LiDAR Quality Assessment Report

Materials Received: 12/19/2011	Project Type: GPSC
Project ID: Arkansas Valley LiDAR	Project Description: Hi res LiDAR
Project Alias(es):	Year of Collection: 2010

Arkansas Valley Lidar

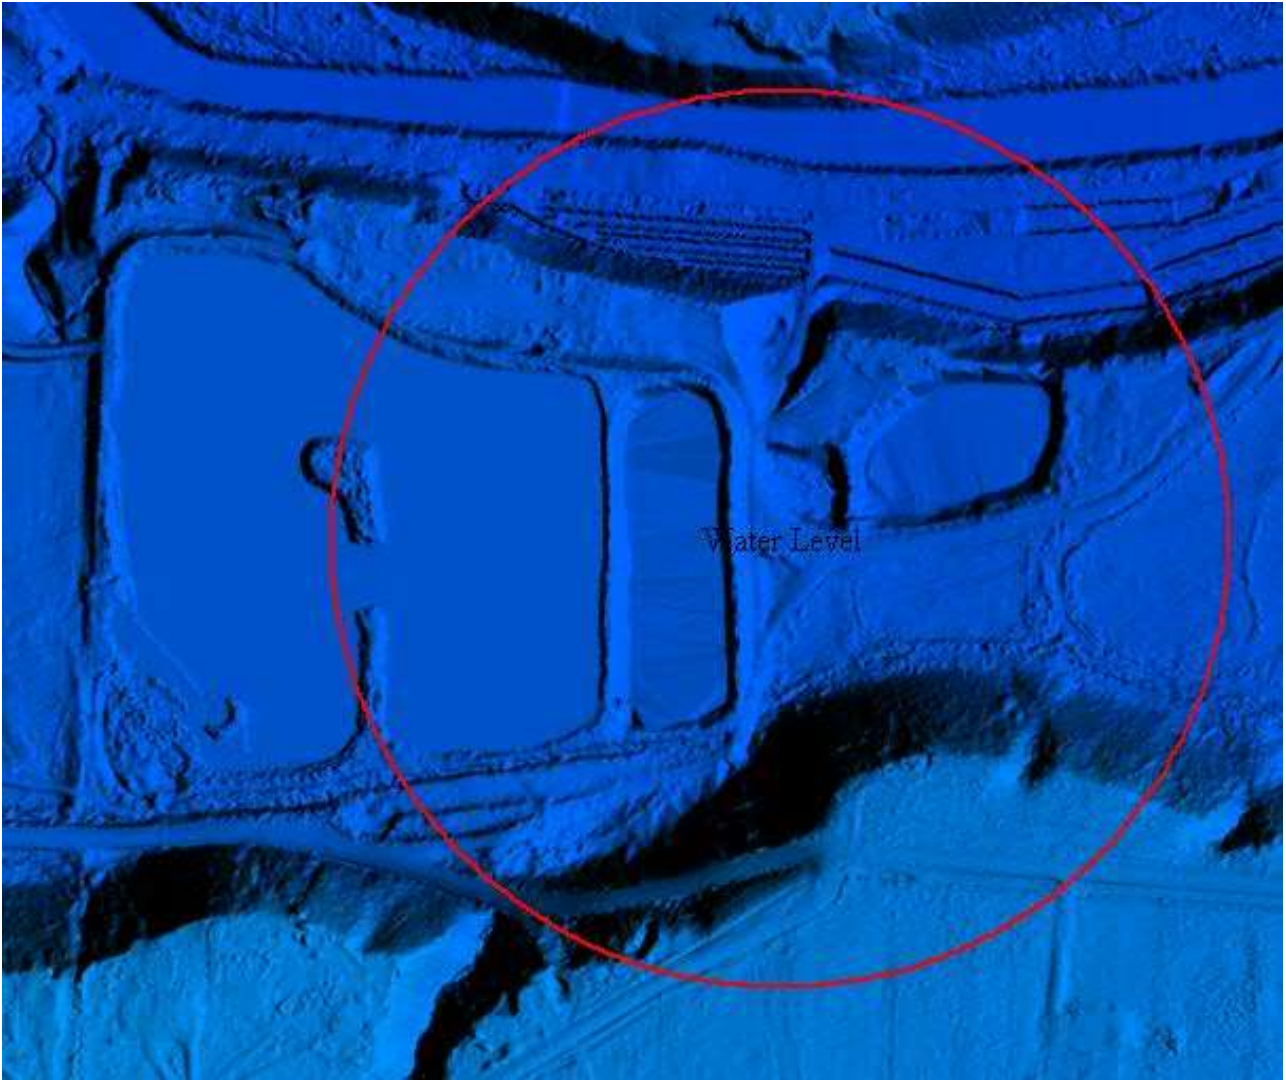
DEM's Extend Beyond the Project Limits Shapefile

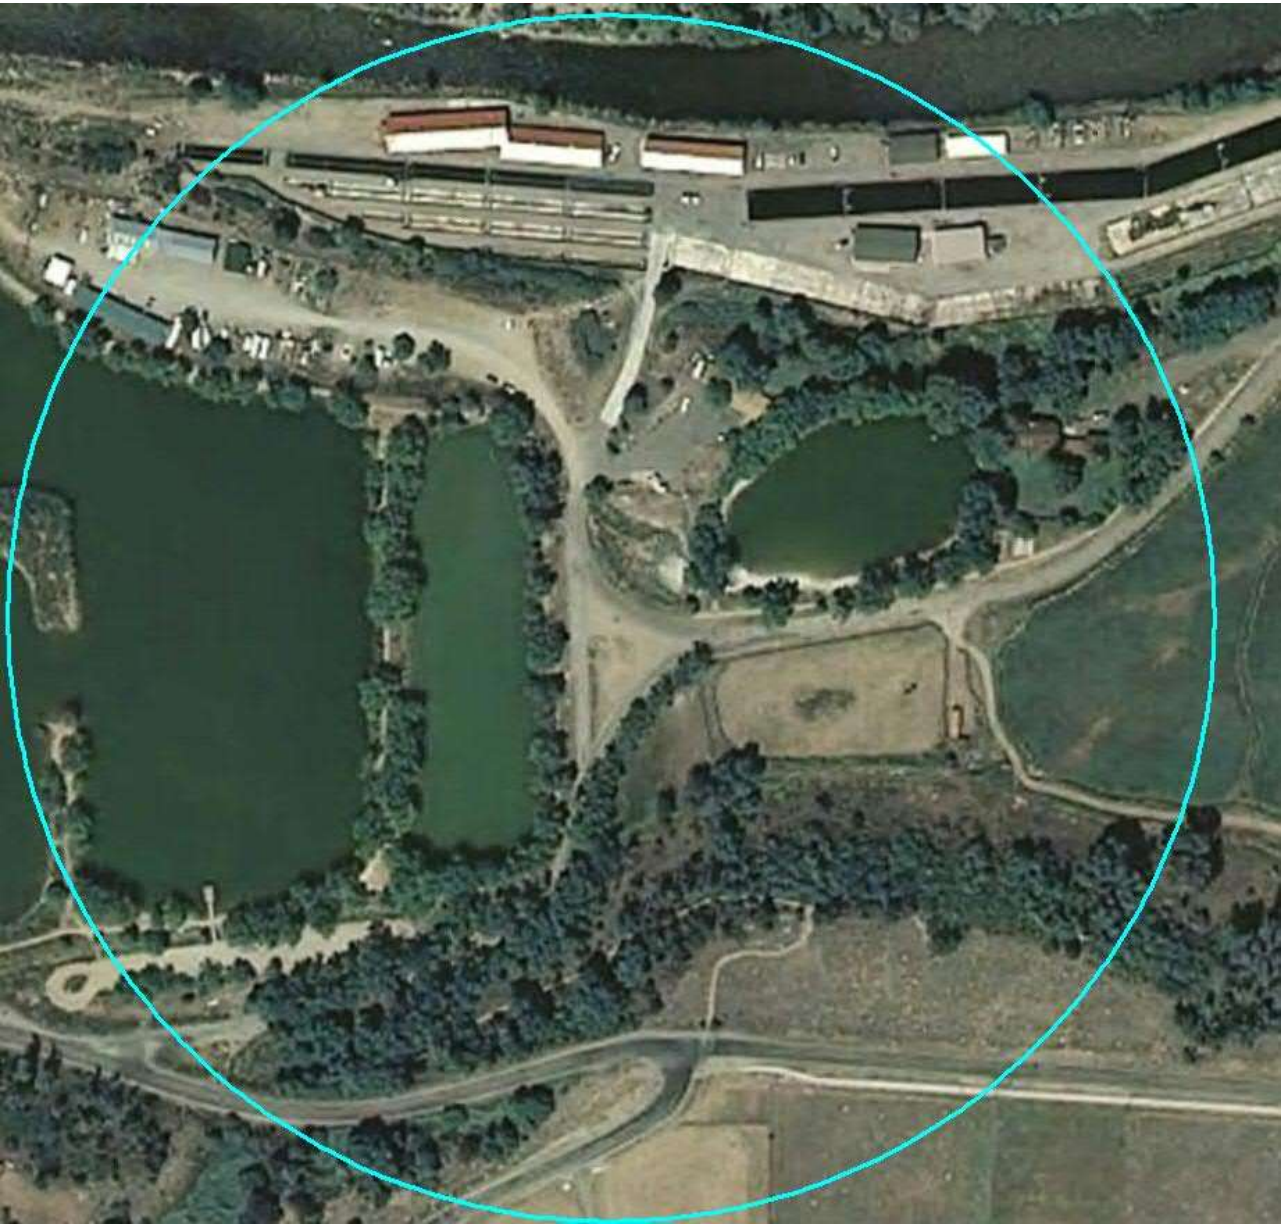
Example of Waterbodies not leveled.

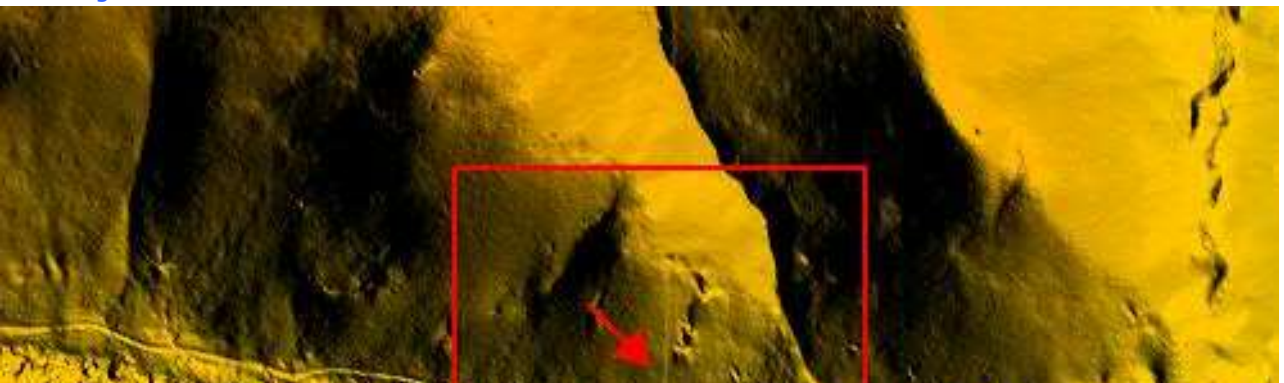
Imagery of water not leveled above. All Water Level Error Tags have confirmed water from imagery like above.

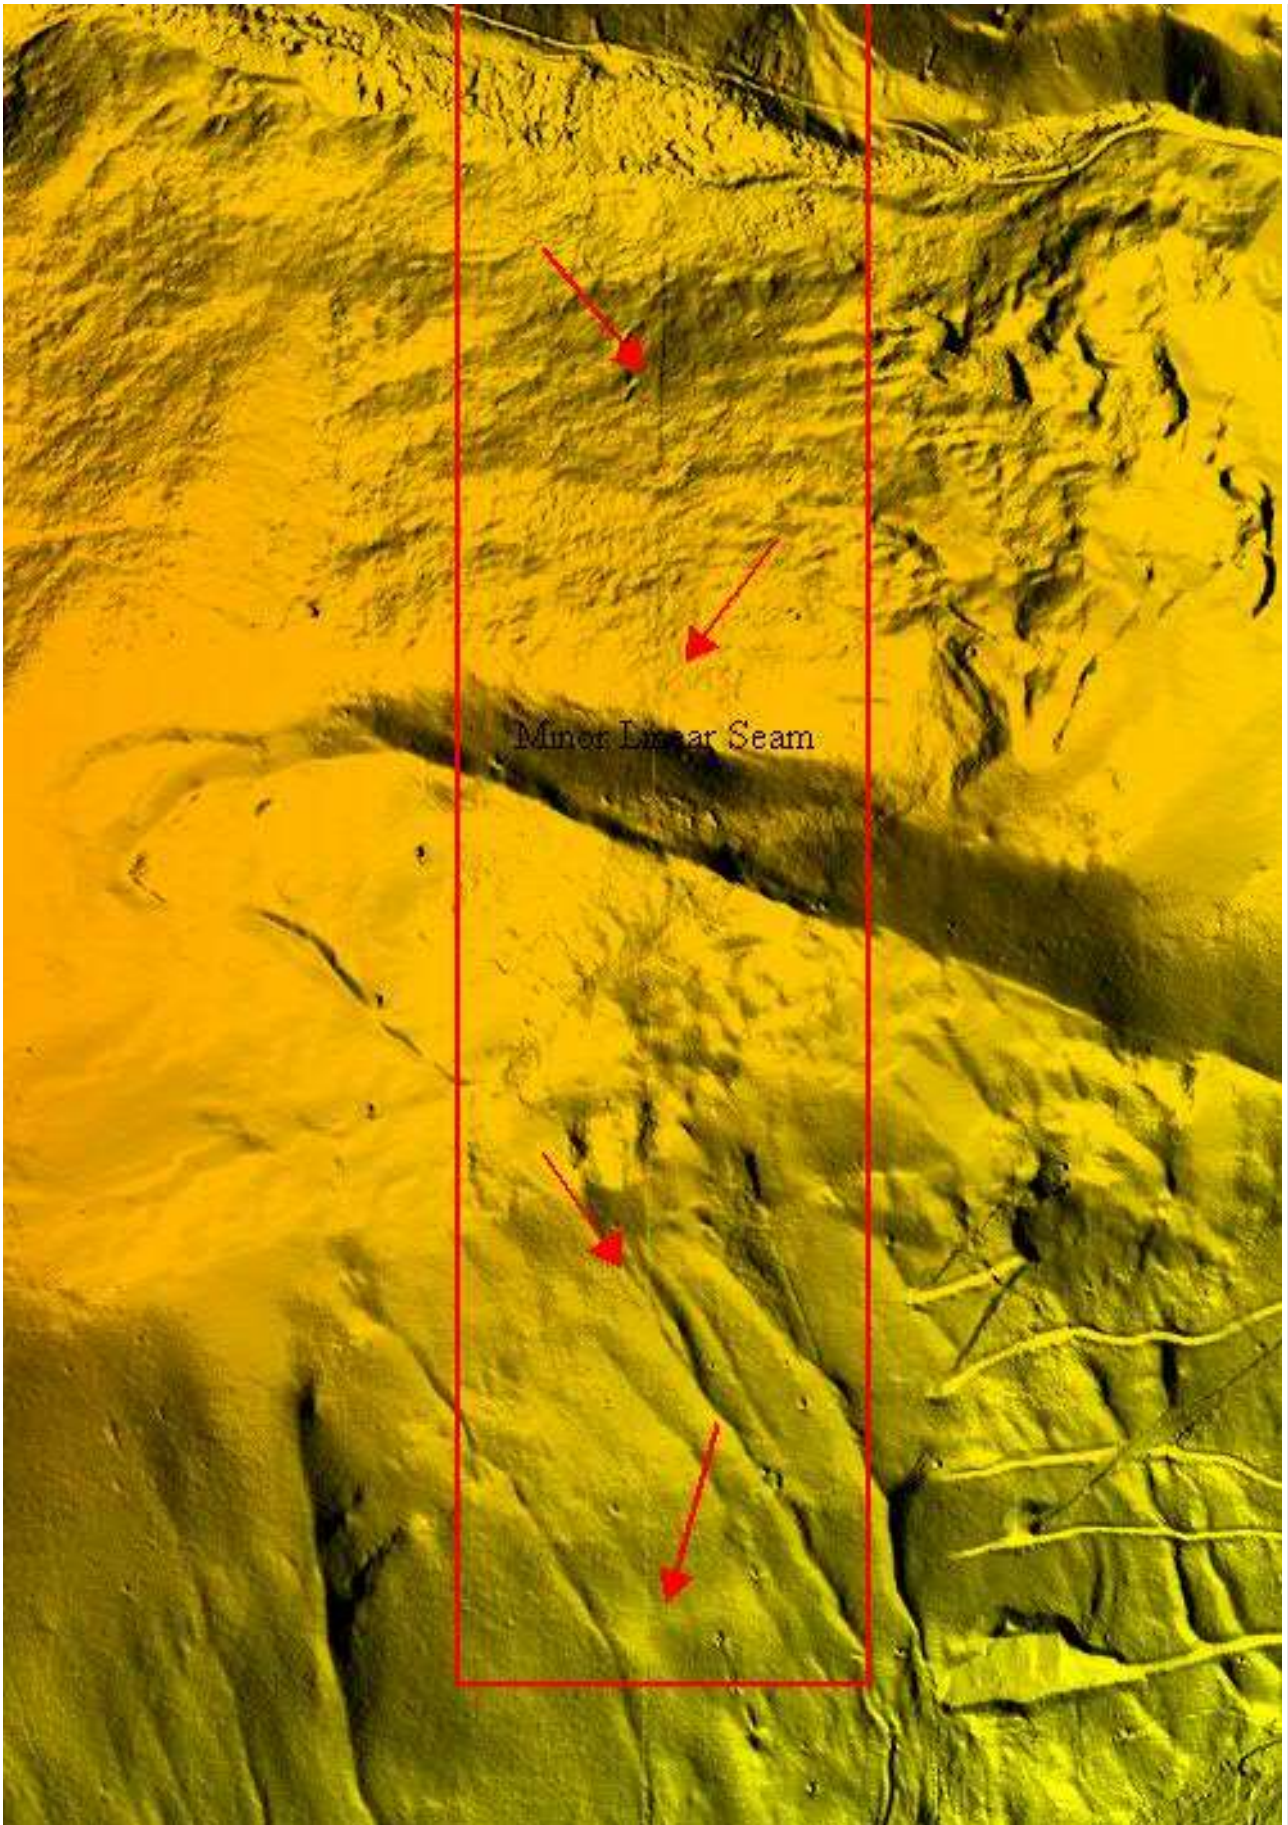
Several Small Seam Areas, no major impact on DEM, no error.
